OPTIMIZATION SUPPORT EVALUATION

GREENWOOD CHEMICAL SITE
NEWTOWN, VIRGINIA

Report of the Optimization Support Evaluation,
Site Visit Conducted at the Greenwood Chemical Site
August 7, 2003

EPA 542-R-04-032
April 2004
www.epa.gov/tio
clu-in.org/optimization

FIGURE 1-2. EXTENT OF VOC CONTAMINATION.

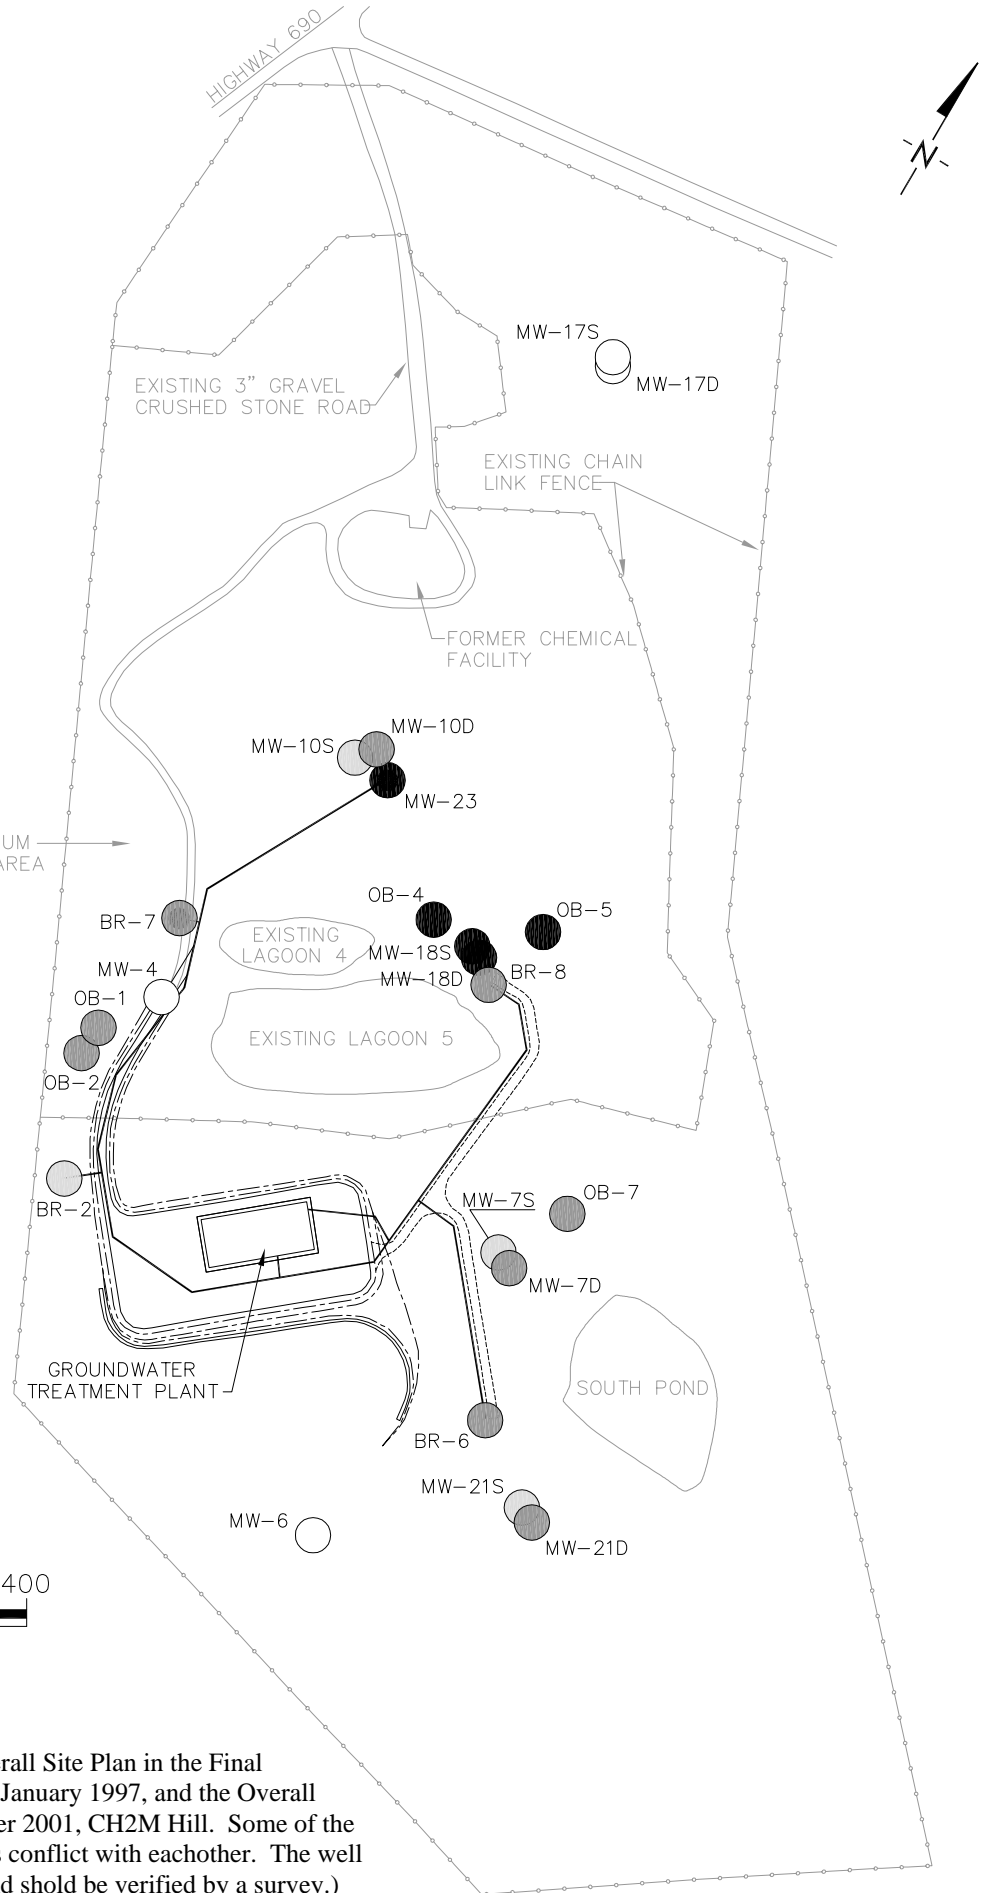
At this site, the plume has not been fully delineated and a target capture zone has not been established. As indicated in Figure 1-2, contamination is present above site-specific standards (and above MCLs) at MW-21S and MW-21D. Contamination (albeit at low concentrations) is also present in BR-2, which is an extraction well that marks the furthest downgradient sampling point (in recent sampling events) on the western side of the property. Many of the deep wells at the site also have contamination with no deeper wells to provide delineation. MW-7D and MW-21D are examples of such wells. The concentrations at MW-7D and MW-21D are higher than at MW-7S and MW-21S (respectively), and it is possible that concentrations below MW-7D and MW-21D might actually increase with depth. The MW-14 cluster, which is adjacent to the MW-7 cluster, has bedrock wells which are deeper than those of the MW-7 cluster, but the sampling data from the past year (4 quarters) indicate that the MW-14 cluster has not been sampled.

We recommend installing additional monitoring wells for delineation. Two clusters of monitoring wells at three depths should be installed downgradient of MW-21D (perhaps 200 to 400 feet downgradient depending on accessibility). The shallow and intermediate wells in each of these clusters might be completed to depths that are comparable to MW-21S and MW-21D. The depths of the deeper wells in each of the clusters would likely need to be determined in the field, but sampling MW-14D prior to the drilling event may provide useful information. MW-14D is located approximately 200 feet upgradient of MW-21D but the elevation of the base of the screen for MW-14D is 140 feet deeper than that of MW-21D. The data reviewed by the OSE team suggested that MW-14D has not been sampled recently. Depending on the results from MW-14D, the site team might consider drilling to a depth of 100 to 200
